FOR PERCOLATION TESTING AND SITE EVALUATION

MEMORANDUM

Greenberry Well Permits

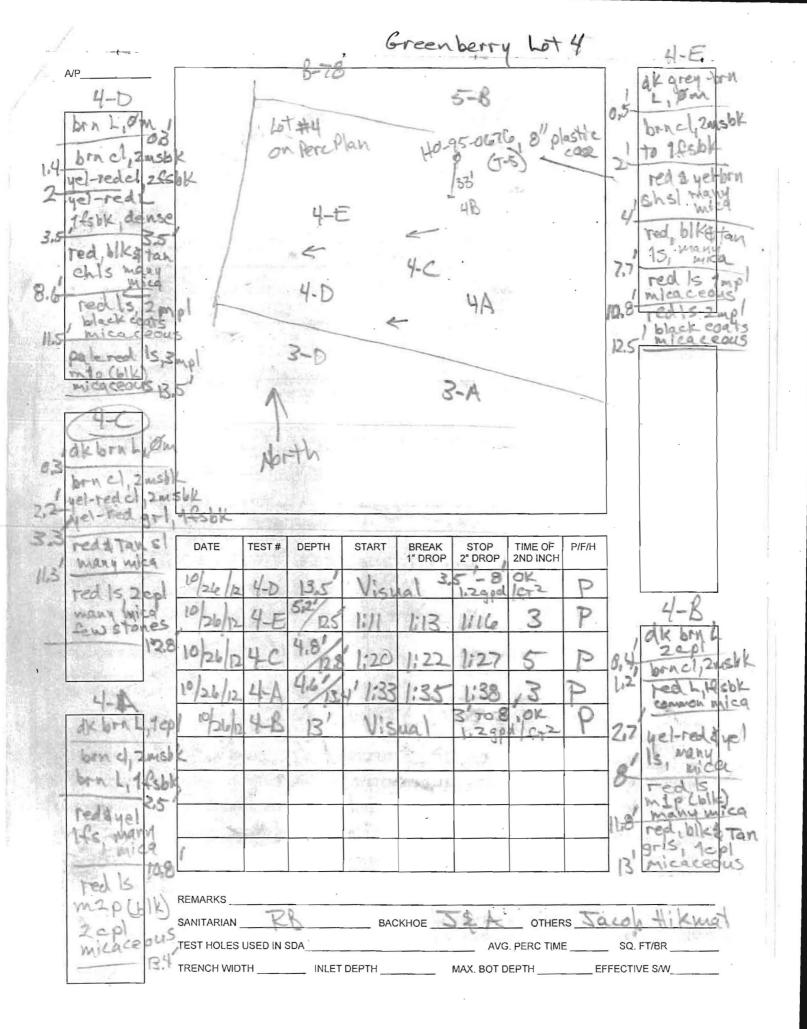
The Percolation Certification for the Greenberry subdivision shows circular well boxes for lots 7, 10, 12, 13, 15, 16, 18, and 19. The center of the well box has been staked and the driller is to drill at the outer perimeter of the well box, 22 feet from the center stake.

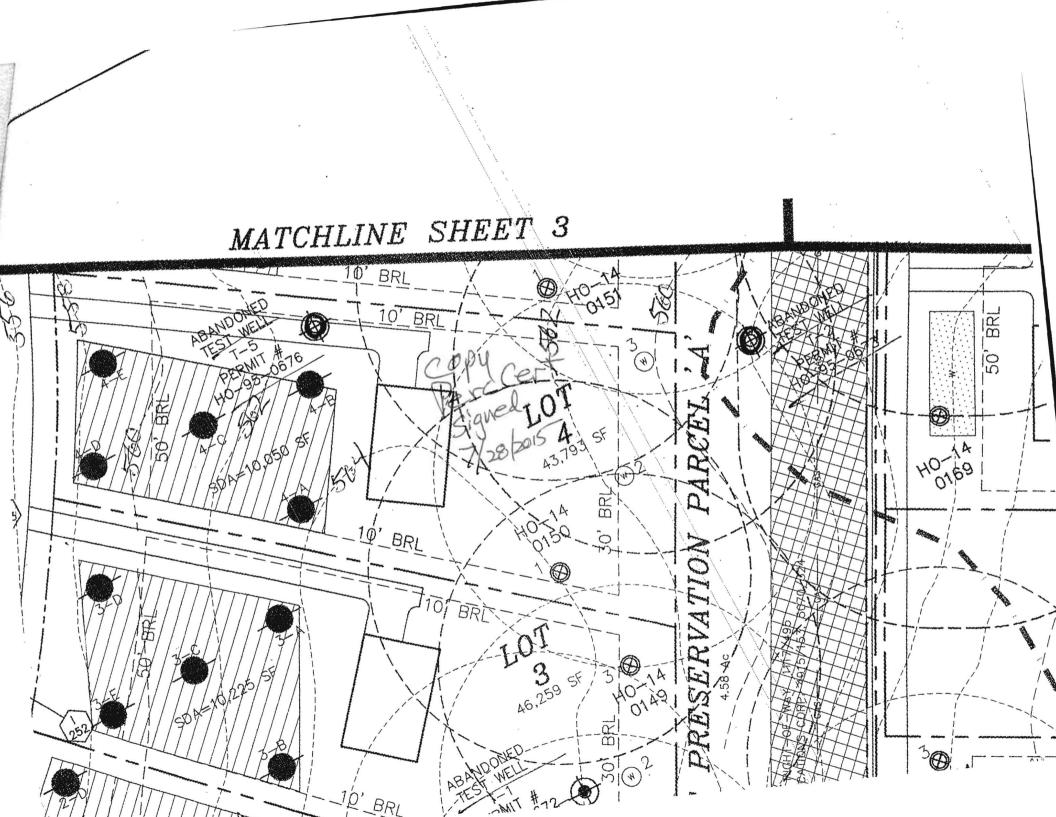
All monitoring and test wells shown on the Percolation Certification are to be sealed. Abandonment reports must be submitted with well completion reports.

At the time of the yield test, a water sample needs to be collected for pesticides testing for lots 2, 3, 4, 5, 10, and 12.

At the time of the yield test, a water sample needs to be collected for TDS, sodium, and chloride testing for lots 4, 9, 11, 14, and 20.
